7 LANCASTER COURT, GILLINGHAM, ME8 0JP.

BS 5837: 2012 Arboricultural Report

24007

MARCH 2024

FIGURE 1. Tree Constraints Plan.

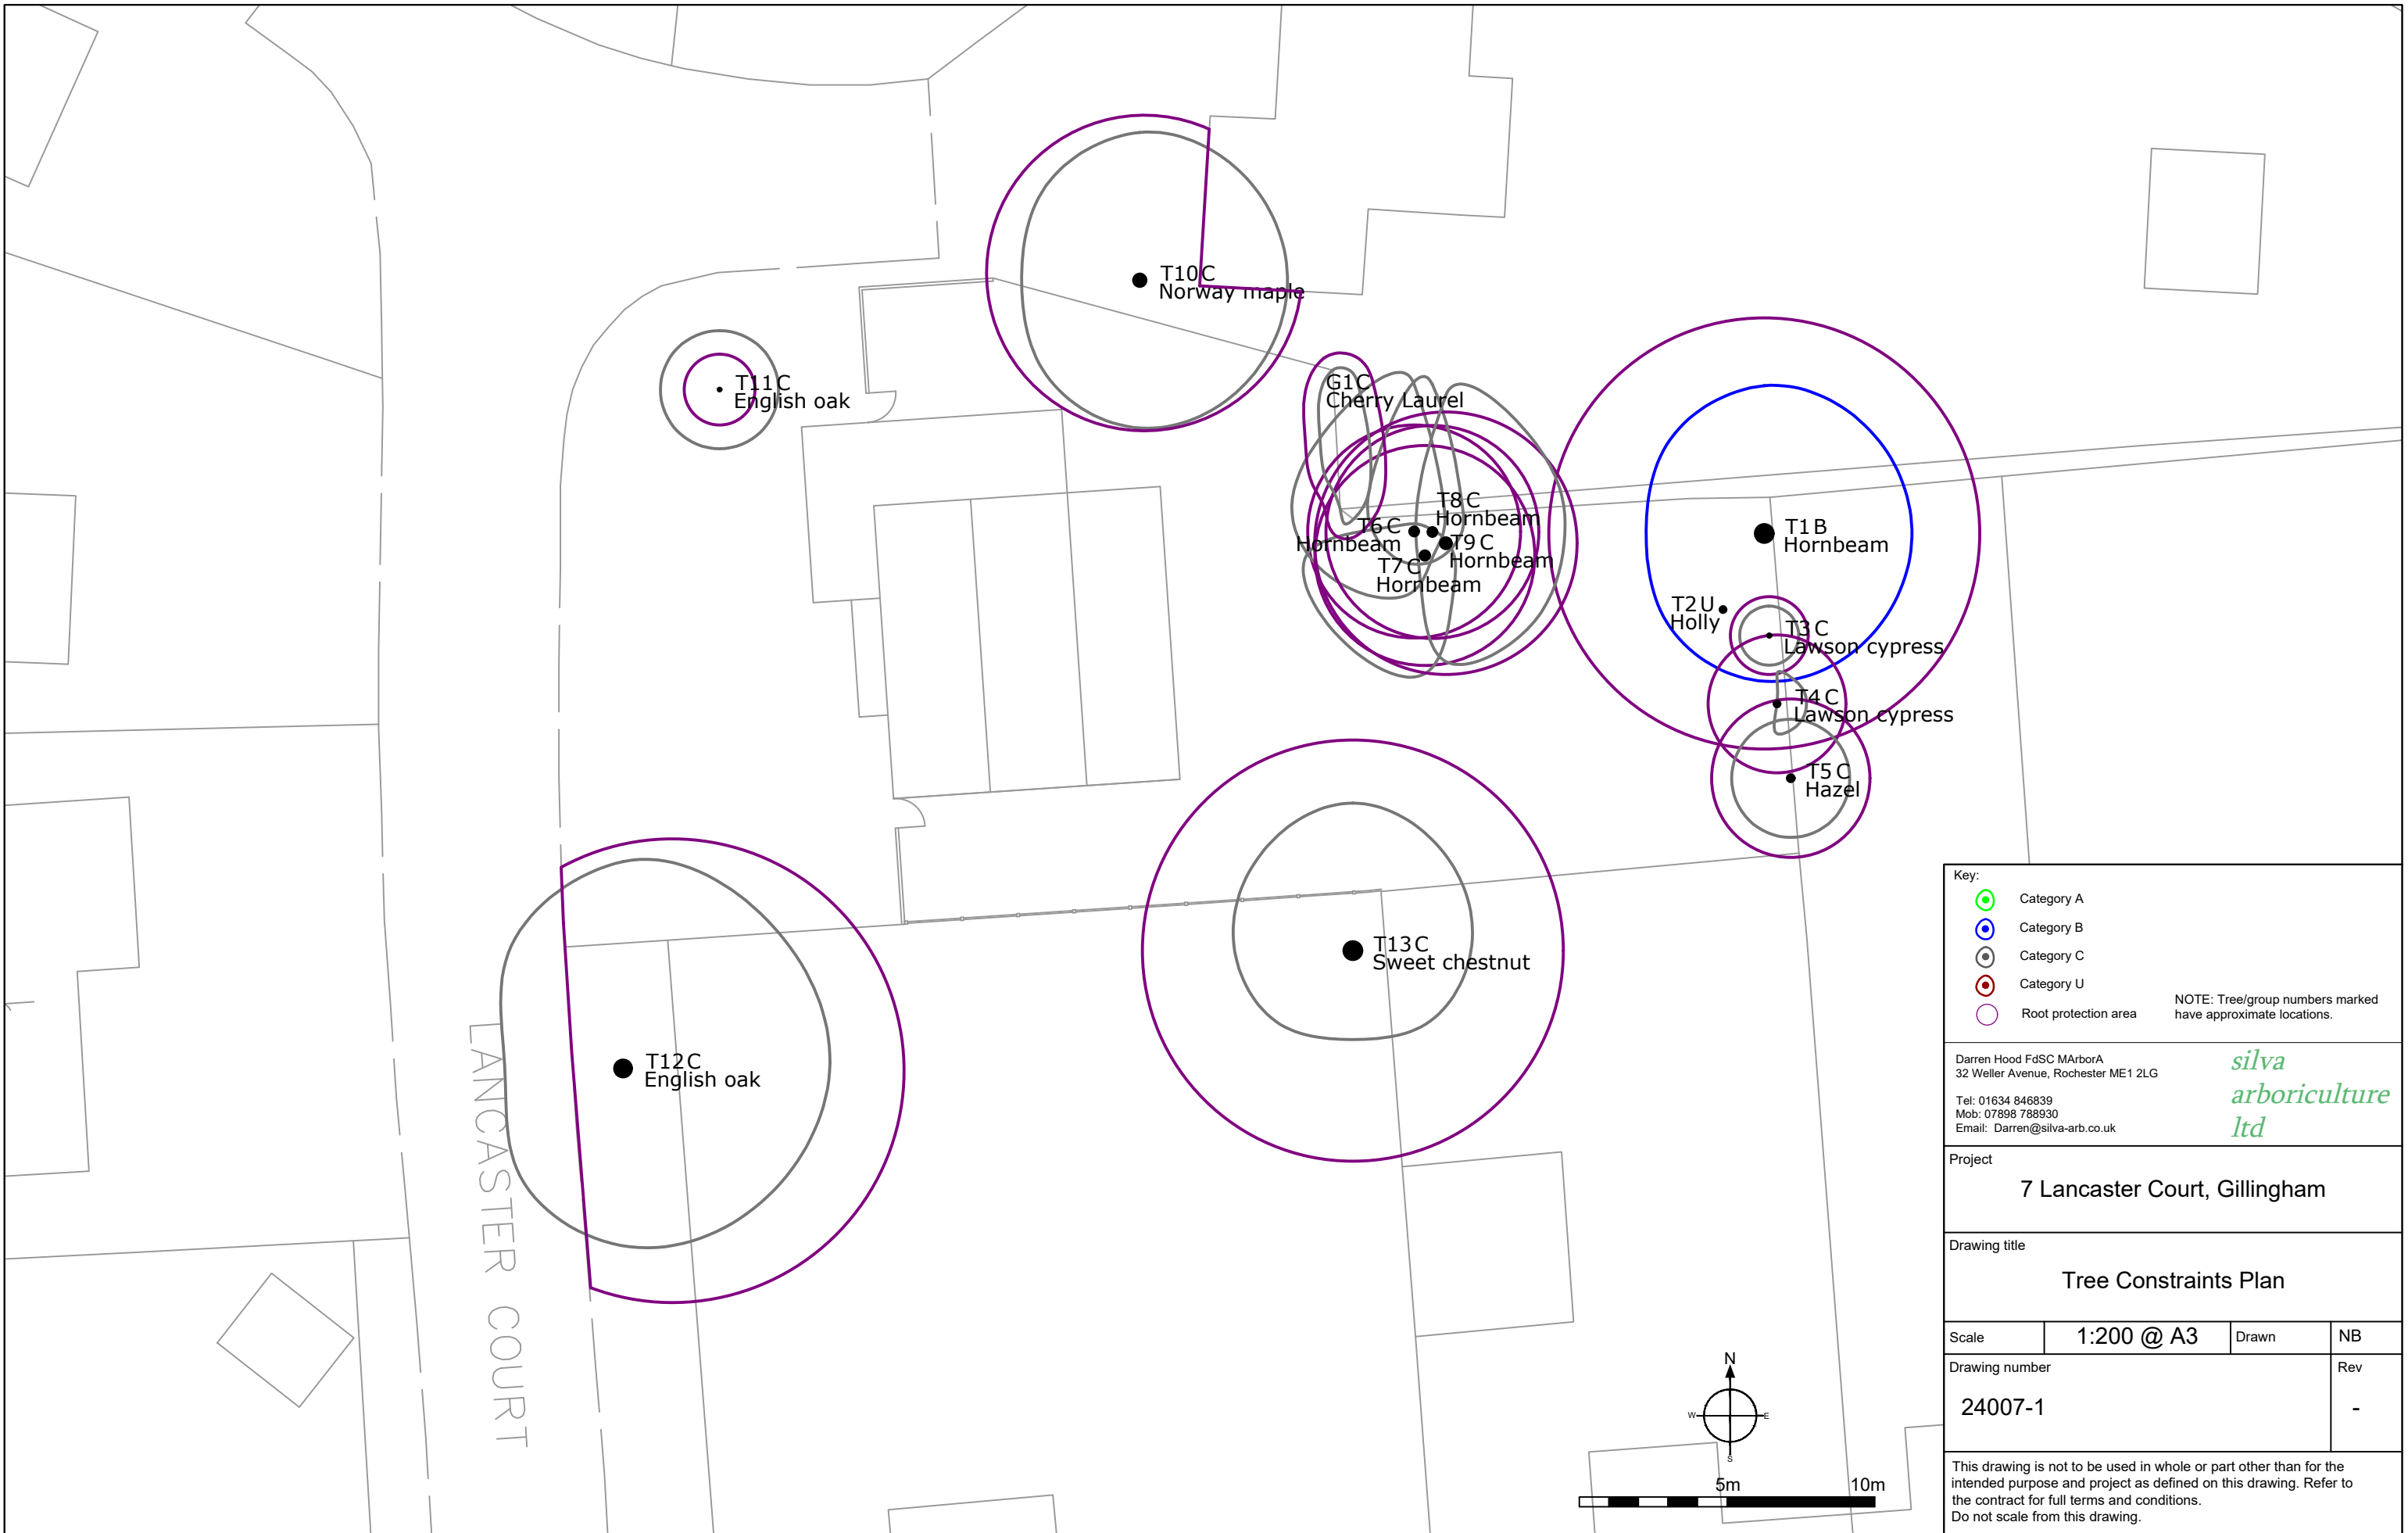
PLAN NOTES – the Cat U Tree (T2) doesn't have a red circle marking its crown (it may be too small?)
